T ECHNICAL INFORMATION

70783

Subject ▶ Change of Strain Relief, Motor Housing, etc.

For Models ▶ 4157KB, 5057KB

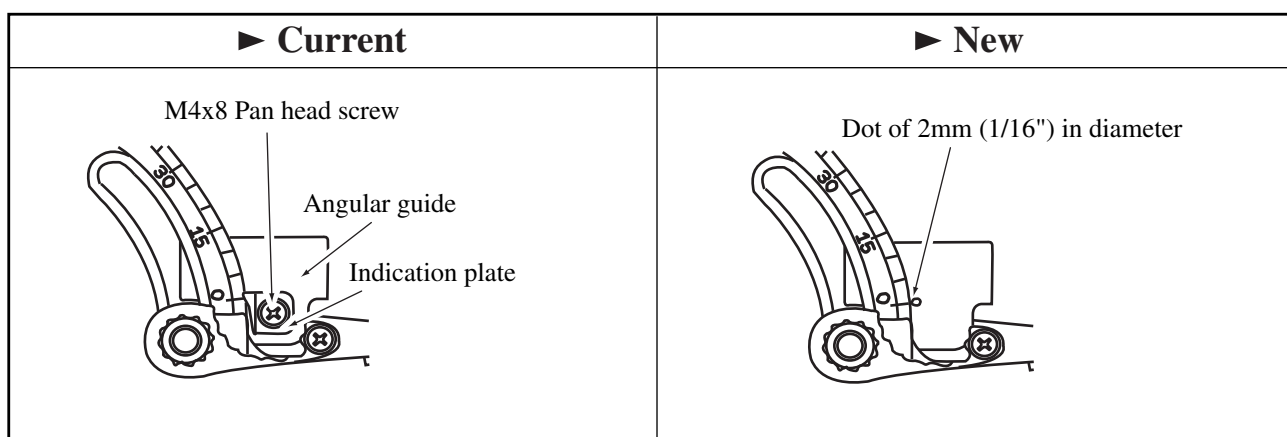
Description ▶ The following parts have been changed to increase assembling efficiency.

- 1) Pitch of Strain relief has been changed from 15 mm (9/16") to 20 mm (13/16").
Also, the pitch of Motor housing for securing a power supply cord has been changed, too.
These changes applies to the specified countries. See note below.
- 2) Indication plate and M4x8 pan head screw for all countries' specifications have been eliminated.
Instead, Angular guide has been modified as illustrated below.
